Access Compliance Report

Public Rights-of-Way

Intersection ID: 24840	Main Street: REA_RD	Cross Street: MACANDREW_DR	Location: NE
ADA ID: 877875D63CA7	Ramp Type: PerpDiag	Initial Pass/Fail: Fail	Overall Compliance: No
Severity Score: 13.75			
Codes/Mitigation Info/Possible Solution		Field Measurements/Component Compliance

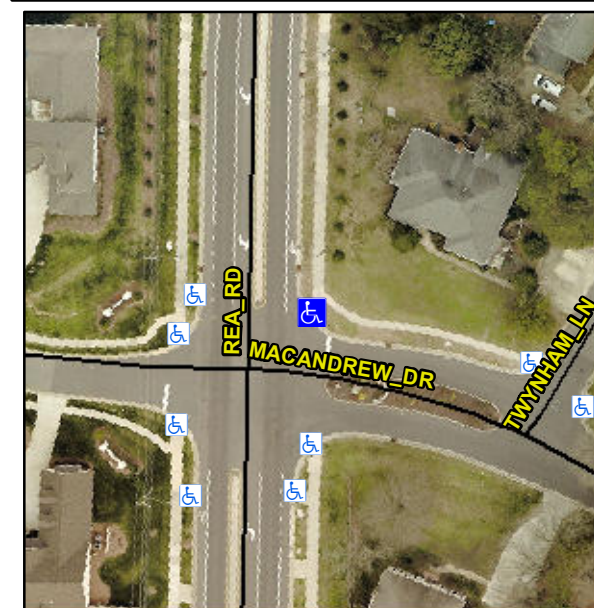
Not Found, R304.2.2, R304.5.3

Compliance	Description	Data	Compliance	Description	Data
N/A	Ramp Length (in)	72.0	No	Ramp Slope (%)	8.8
Yes	Ramp Width (in)	96.0	No	Ramp XSlope (%)	3.2
N/A	Flare Type LT	N/A	N/A	Flare Type RT	N/A
N/A	Flare Slope LT (%)	N/A	N/A	Flare Slope RT (%)	N/A
N/A	Flare Traversable LT?	N/A	N/A	Flare Traversable RT?	N/A
N/A	Landing Length (in)	N/A	N/A	DWS Provided?	N/A
N/A	Landing Width (in)	N/A	N/A	DWS Contrast?	N/A
N/A	Landing Slope (%)	N/A	N/A	DWS Length (in)	N/A
N/A	Landing X Slope (%)	N/A	N/A	DWS Full Width?	N/A
N/A	Landing Curb? (Y/N)	N/A	N/A	DWS Offset (in)	N/A
N/A	Shared Landing?	N/A			
N/A	Gutter Ponding?	N/A	N/A	Gutter Slope (%)	N/A
N/A	Gutter Lip Ht (in)	N/A	N/A	Gutter X Slope (%)	N/A
N/A	Painted X Walk1?	No	N/A	Painted X Walk2?	No
	X Walk 1 Direction	To W		X Walk 2 Direction	To S
N/A	X Walk 1 Width (in)	N/A	N/A	X Walk 2 Width (in)	N/A
	X Walk 1 Slope (%)	1.9		X Walk 2 Slope (%)	1.2
	X Walk 1 X Slope (%)	0.6		X Walk 2 X Slope (%)	1.9

Remove & Replace Curb Ramp With Two New Directional Ramps or Equivalent.
